ZONING PLAN
FOR
SHALLOWFORD PLACE
LOCATED IN LAND LOT 400,
16TH DISTRICT, COBB COUNTY, GEORGIA

PETITION NO: Z-111

Z-111-2016 GIS

ZONING COMMENTS:

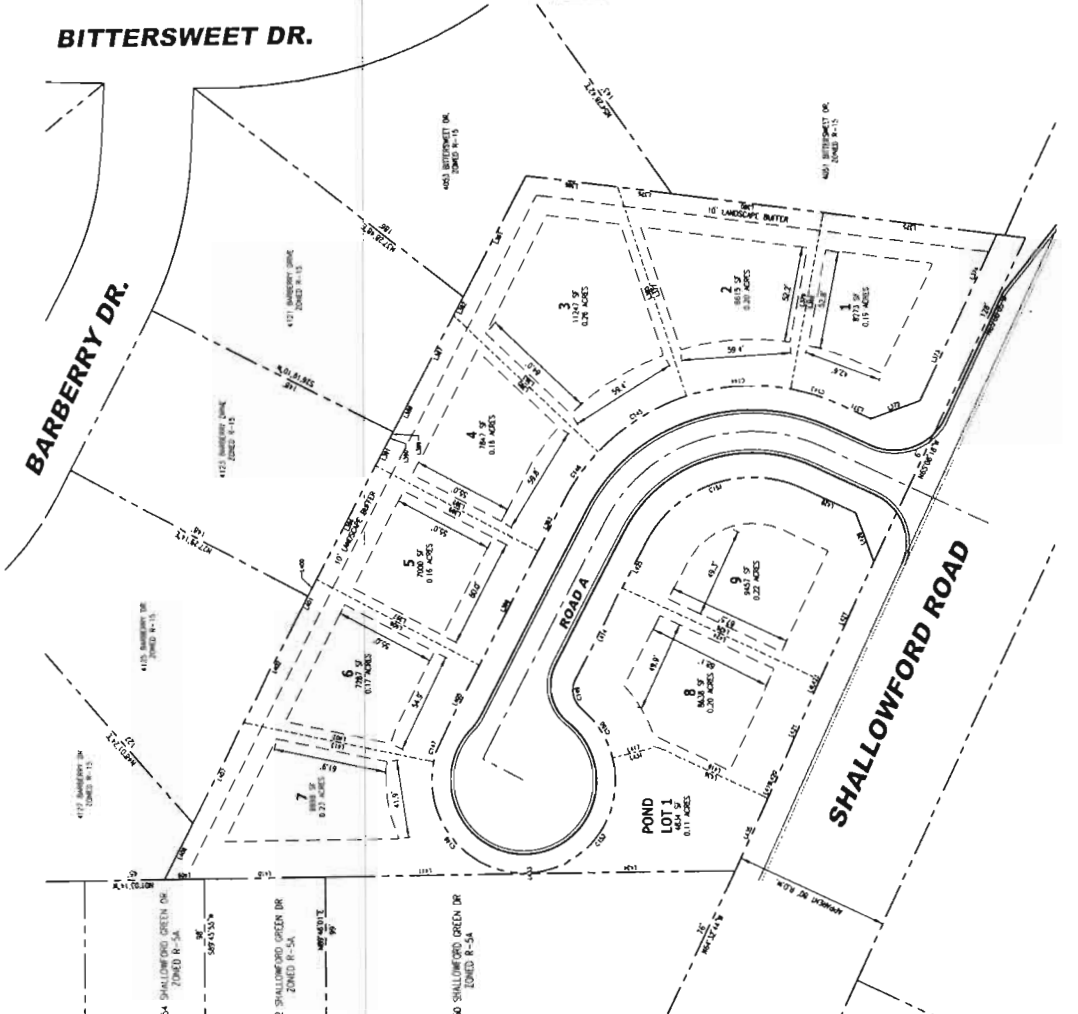
The applicant is requesting a rezoning to the RA-5 single-family residential district in order to develop nine (9) detached single-family homes. That district’s minimum lot size of 7,000 sq. ft. will be met with the lots ranging from 7,000 sq. ft. to 11,247 sq. ft. The proposed homes will be a minimum of 2,500 square feet and be constructed with brick, stone, stacked stone, cedar shake, board and batten, or combinations thereof. Anticipated selling prices will be starting in the high \$500,000s. The Code-required 10 foot landscape buffer is provided adjacent to more restrictively zoned (R-15) properties.

If approved, the following contemporaneous variance are needed:

1. Waive the rear setback from the required 40 feet to 20 feet with an increase of the front setback from the required 20 feet to 25 feet.

1. This site is located just north of Shallowford Road and is bounded on the north and east by Hedgerow Subdivision and on the west by Shallowford Green Subdivision. Slopes on the site are relatively mild ranging from 2 to 10%. The majority of the site (2/3) drains to the Shallowford Road R/W. The remaining third drains to the east into the Hedgerow Subdivision Recreation Area.
2. Any bypass runoff from the rear of lots 1 through 7 must be directed to the Shallowford Road right-of-way and not to the Hedgerow Rec Area.

Shallowford Road is classified as an arterial and according to the available information the existing right-of-way does not meet the minimum requirements for this classification.

Recommend applicant consider entering into a development agreement pursuant to O.C.G.A. 36-71-13 for dedication of the following system improvements to mitigate traffic concerns: a) donation of right-of-way on the north side of Shallowford Road, a minimum of 50' from the roadway centerline.

Recommend curb and gutter along both sides and sidewalk along one side of proposed development roadway.

Recommend guest parking be located outside of the right-of-way.

1. Site plan received by Zoning Division on October 6, 2016 with District Commissioner approving minor modifications;
2. Fire Department comments and recommendations;
3. Water and Sewer Division comments and recommendations;
4. Stormwater Management Division comments and recommendations;
5. Department of Transportation comments and recommendations;
6. Owner/developer to enter into a Development Agreement pursuant to O.C.G.A. §36-71-13 for dedication of system improvements to mitigate traffic concerns; and
7. House architecture to be approved by the District Commissioner.
